Reference number ISO 3964:2016/Amd.1:2018(E)

Dentistry — Coupling dimensions for handpiece connectors

AMENDMENT 1

Figure 5

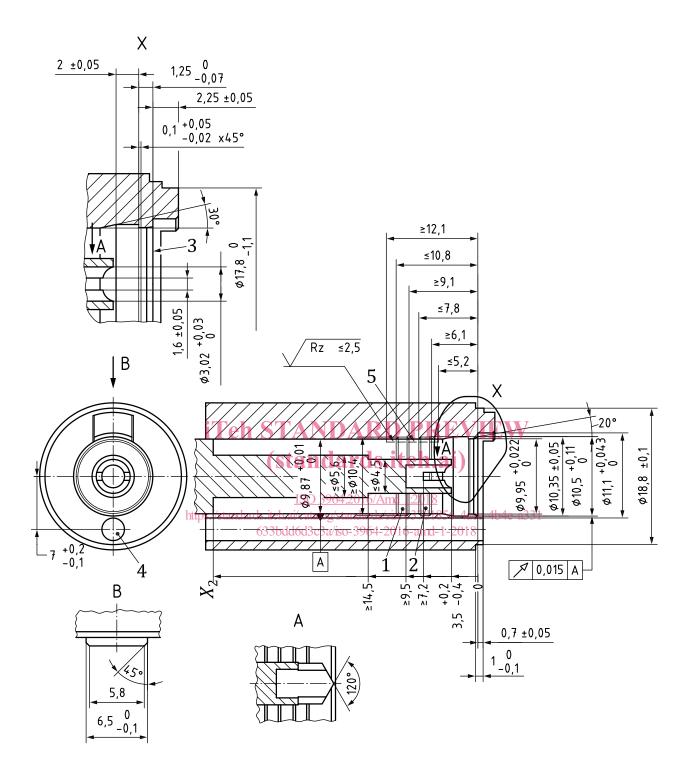
Replace the tolerance for dimension "Ø18,8 $_{-0,1}^{0}$ " with "Ø18,8 ± 0,1" Replace the tolerance for dimension "Ø 17,8 $_{-0,1}^{0}$ " with "Ø17,8 $_{-1,1}^{0}$ ". Replace the tolerance for dimension "≥10,8" with "≤10,8". Replace the tolerance for dimension "≥7,8" with "≤7,8". Replace the tolerance for dimension "≤6,1" with "≥6,1". Replace Figure 5 with the following Figure:

Figure 6

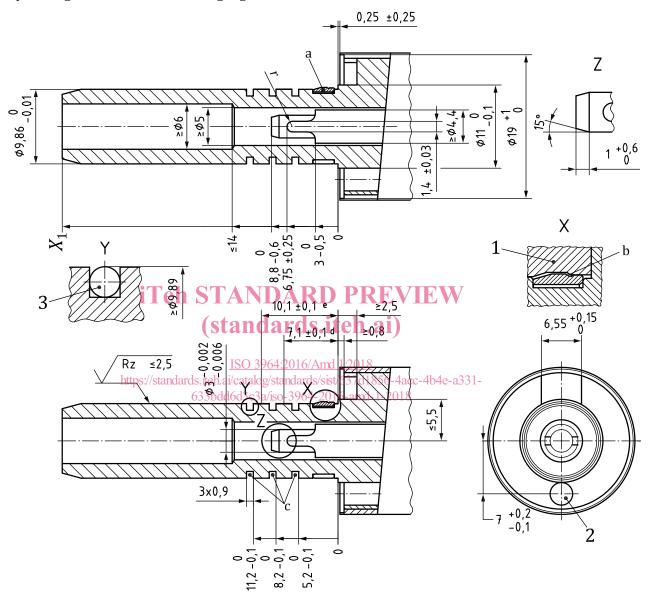
Correct error in the upper and lower part of drawing, left section, right side for the motor body. Replace Figure 6 with the following Figure:

Figure 7

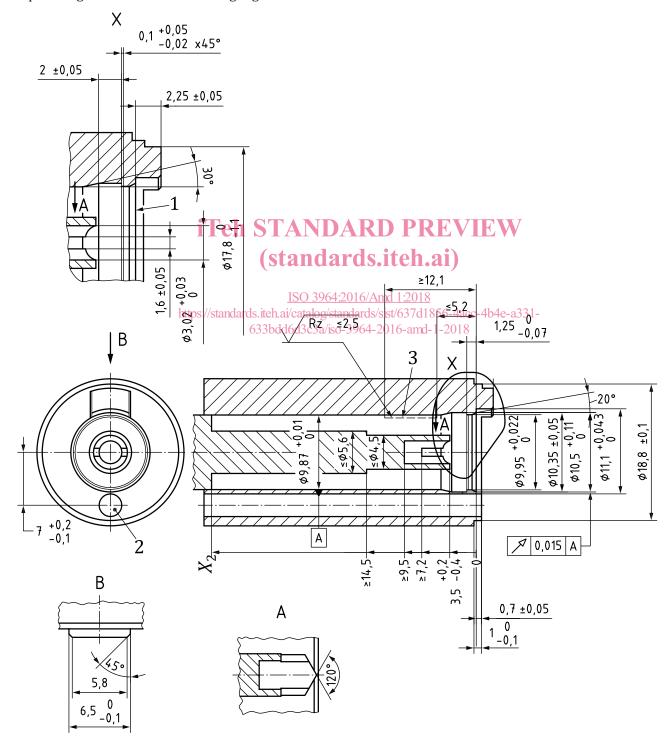
Replace the tolerance for dimension " $Ø18,8 \stackrel{0}{_{-0,1}}$ " with " $Ø18,8 \pm 0,1$ ". Replace the tolerance for dimension " $Ø17,8 \stackrel{0}{_{-0,1}}$ " with " $Ø17,8 \stackrel{0}{_{-1,1}}$ ". Add the detail designation "X" to the top of the enlarged view (upper left side). Replace Figure 7 with the following Figure:
